ENGINEERING TECHNICAL BULLETIN No. 107

**Improving the Noise Level
of the
SP-600 Receiver
using a
Nuvistaplug**

STOCK NUMBER: 5960-H00-9058

March 1965

FIGURE :1- NUVISTA PLUG SCHEMATIC

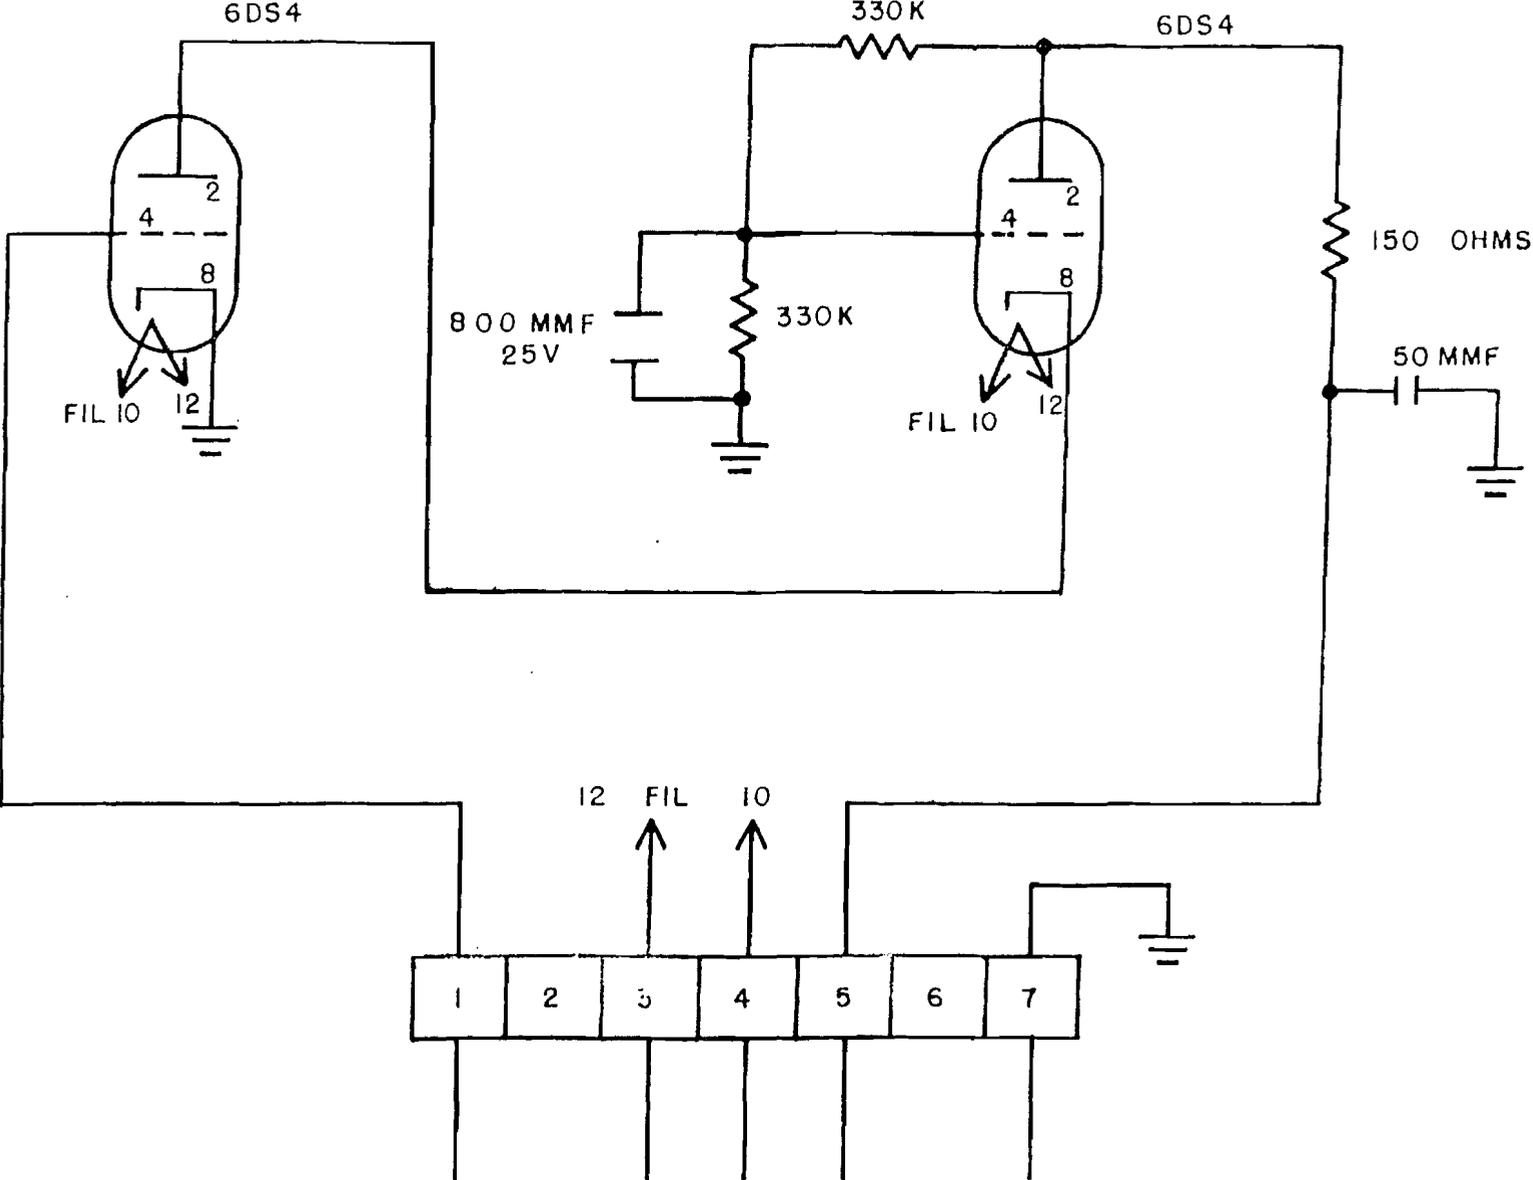
By combining the miniature, low noise, high amplification triodes (RCA Nuvistor Type 6DS4) in a cascade arrangement, the Nuvistaplug is able to take advantage of the triode's low noise while retaining, essentially, the desirable amplification characteristics of the pentode it replaces (See Schematic, Figure 1). No circuit changes are necessary when the Nuvistaplug is used, and only slight compensating adjustments are needed in most cases.

3. Replace the V1 tube 6BA6 in the first RF amplifier stage with the Nuvistaplug Model 675.
4. Set the MOD-CW switch to CW and the AVC-MANUAL switch to MANUAL; set the RF gain for best sensitivity. Tune the receiver until the CW source is heard.
